**STAFF REPORT & FINDINGS OF FACT
FLORENCE COMMUNITY DEVELOPMENT DEPARTMENT
Planning Commission
Exhibit "A"**

Public Hearing Date: January 24, 2017 **Planner:** Glen Southerland
Date of Report: January 17, 2017
Application: PC 16 11 DR 03

Proposal: A request for a design review approval for exterior modifications to the Dairy Queen restaurant located within the Mainstreet Area "A" zoning district.

**SITE
PHOTOMETRIC
PLAN**

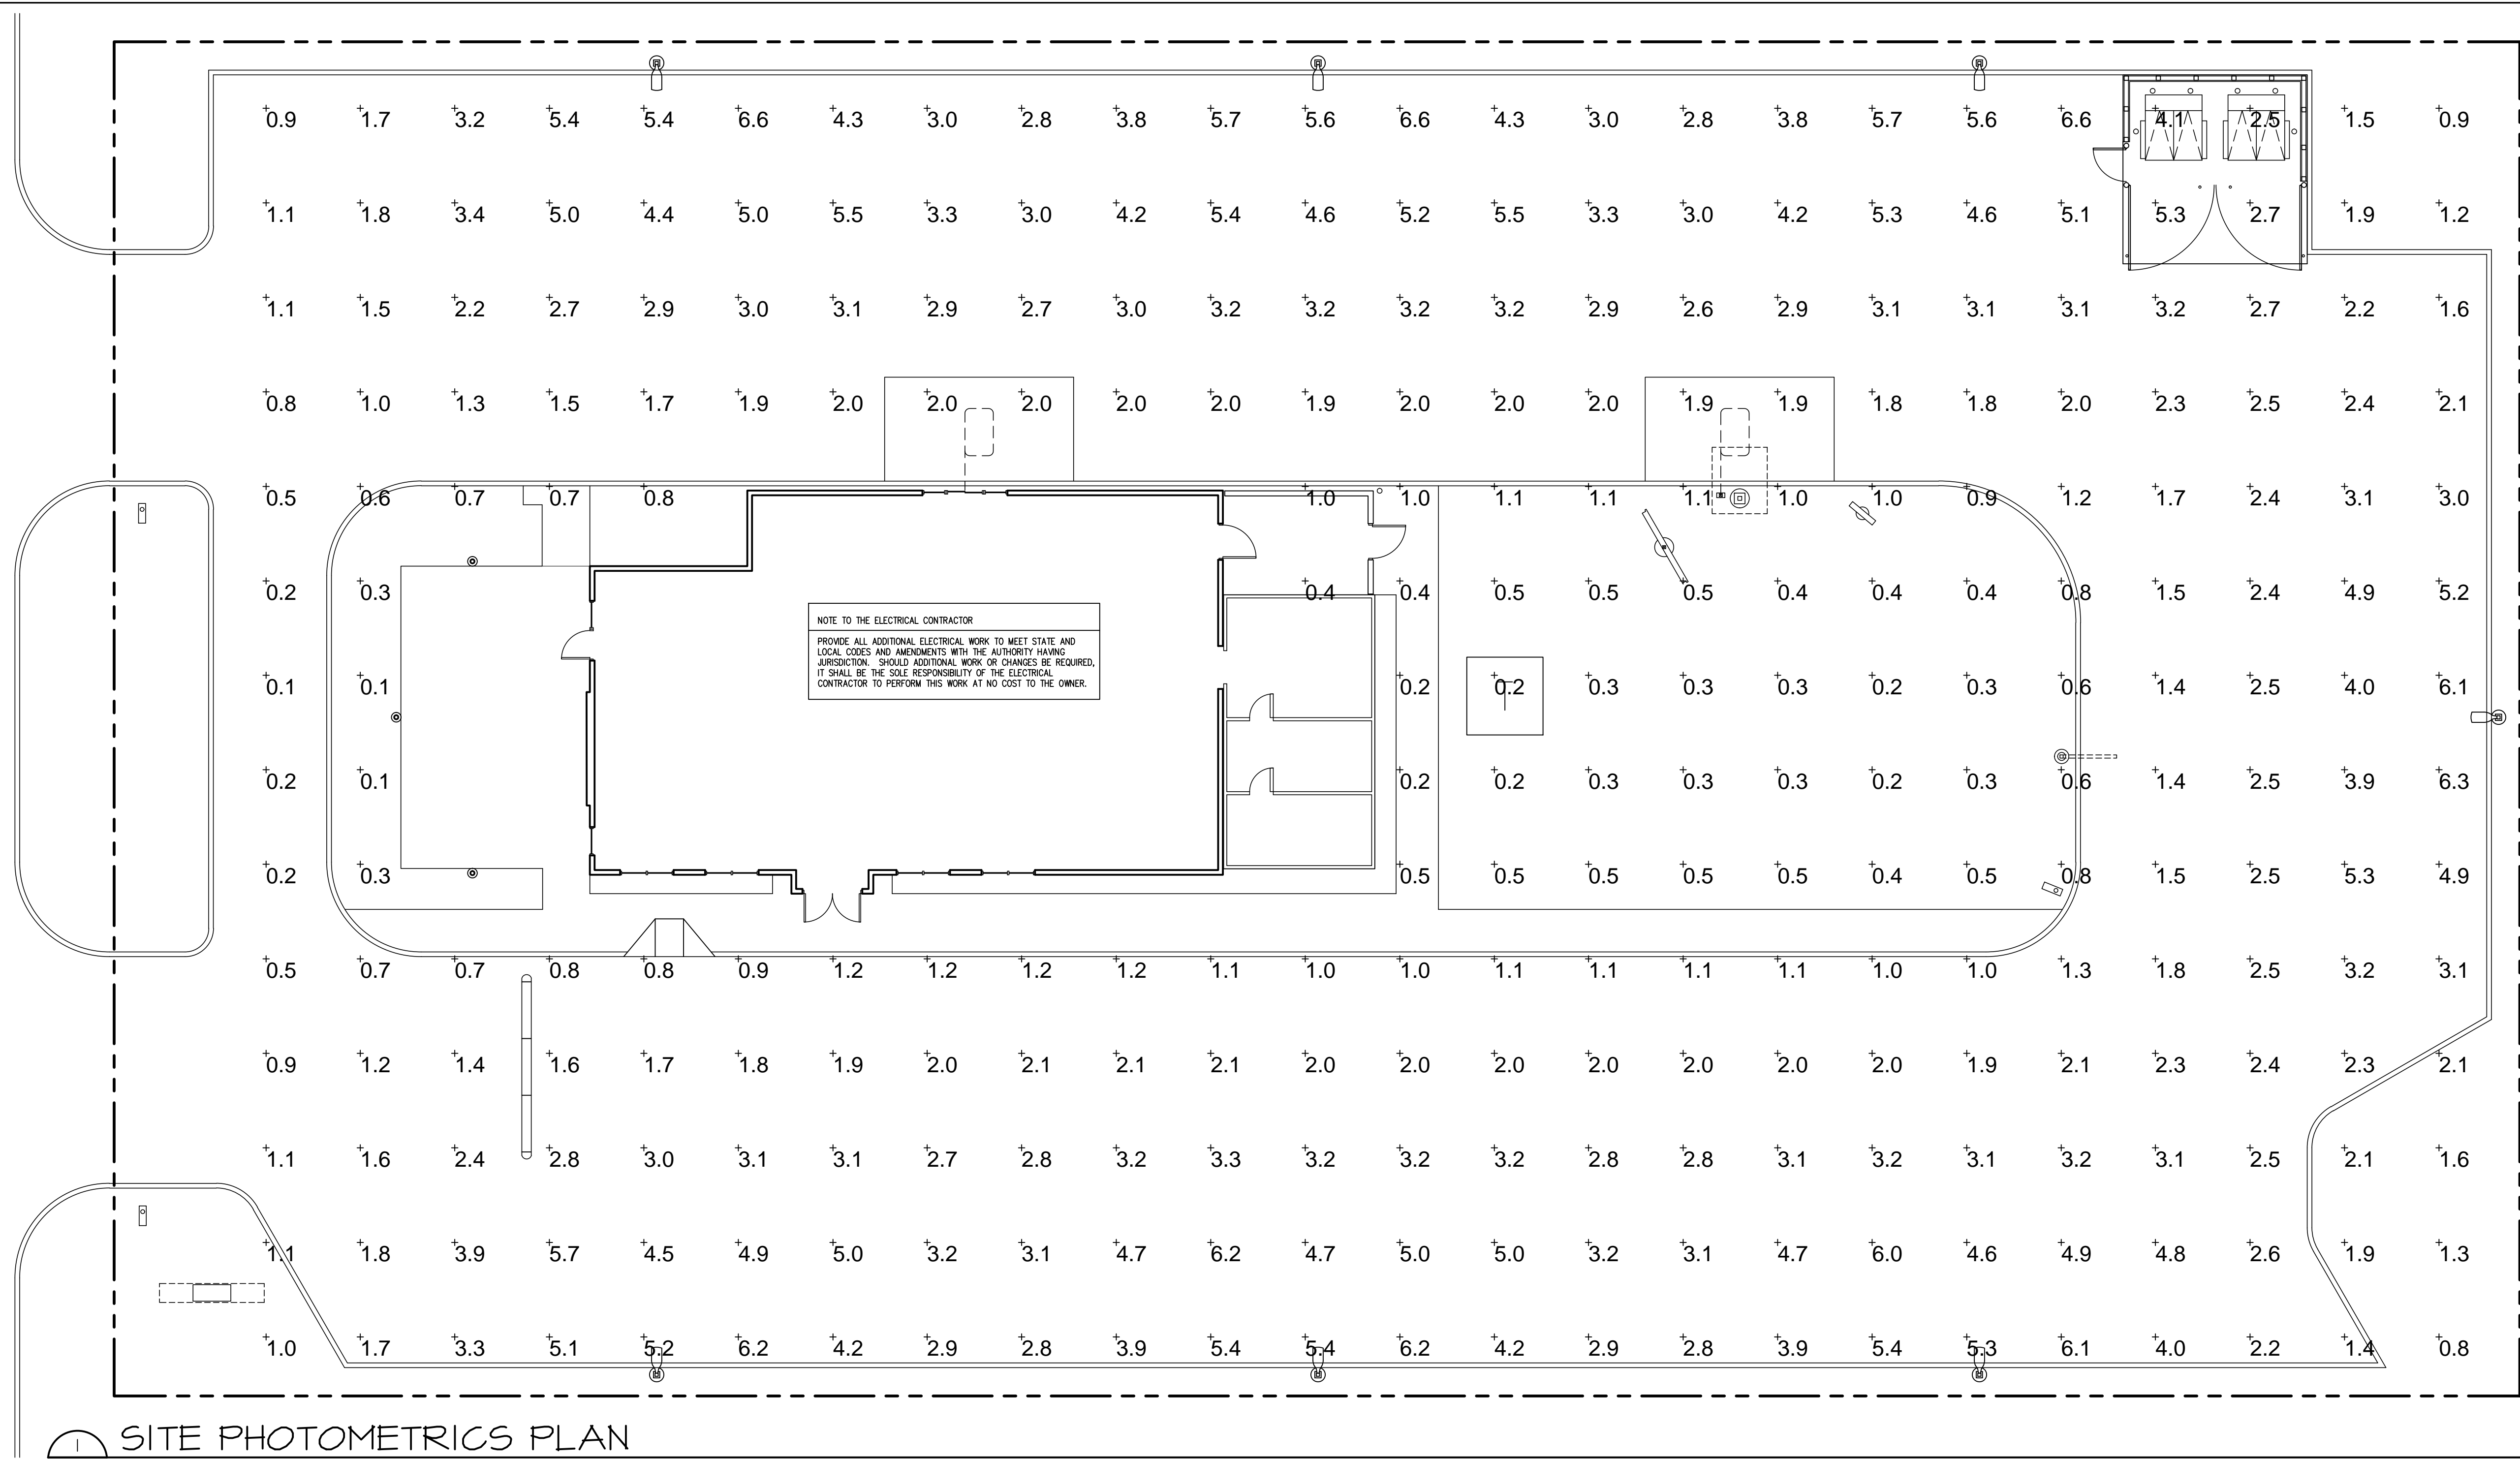
The applicant submitted a photometric plan which does not match the site. No fixture information was included to explain construction or light output of the selected luminaires. Some information regarding the lit building eyebrow was included, but this information did not state the luminosity of the fixture.

The applicant has not provided information about the lighting fixtures selected or where those fixtures would be projected. Staff researched the lighting fixtures called out on the lighting plan submitted and was unable to determine from the information provided whether the lighting fixtures would meet the intent of FCC 10-37. Some information provided called out uplights mounted in the eyebrow, whereas other information stated that all lighting would be downward-facing.

The applicant shall submit a photometric plan for review of compliance with FCC 10-37 prior to issuance of building permits. **(Condition 6.1)**

The applicant shall ensure lighting fixtures selected are full cut-off fixtures or have a shielding method to direct light emissions downward below the horizontal plane onto the site and that lighting fixtures do not project light skyward or onto adjacent or nearby property. Lighting fixture information shall be provided for review and approved by the Planning Department prior to issuance of building permits. **(Condition 6.2)**
